Mobile Intel® Celeron® Processor at 466 MHz, 433 MHz, 400 MHz, 366 MHz, 333 MHz, 300 MHz, and 266 MHz Specification Update

Release Date: March 2002

Order Number: 244444-030

Figure 2. Workaround Flowchart: SMBALERT#-Driven System

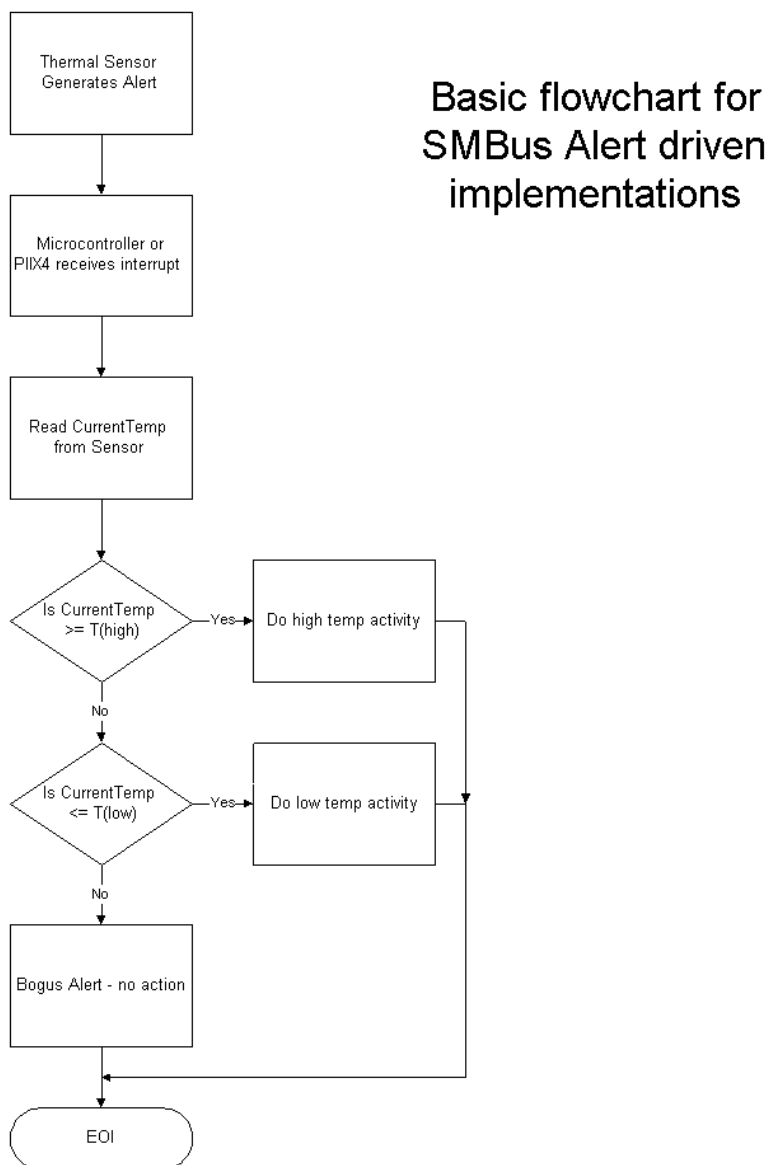
Workaround: Three different (mutually exclusive) workarounds are possible:

1. Before servicing an interrupt from the thermal sensor, read and compare the processor thermal reading with the threshold limits (T_{HIGH} or T_{LOW}). Figures 2 and 3 provide basic flowcharts for the implementation of this workaround in an interrupt driven system.
2. If the firmware implemented polls the Status Register only, then before taking any action, re-read the temperature register and do a comparison with the alarm threshold limits (T_{HIGH} or T_{LOW}) to determine if the value is actually still within the temperature window.
3. Use a temperature polling scheme to monitor the processor temperature.
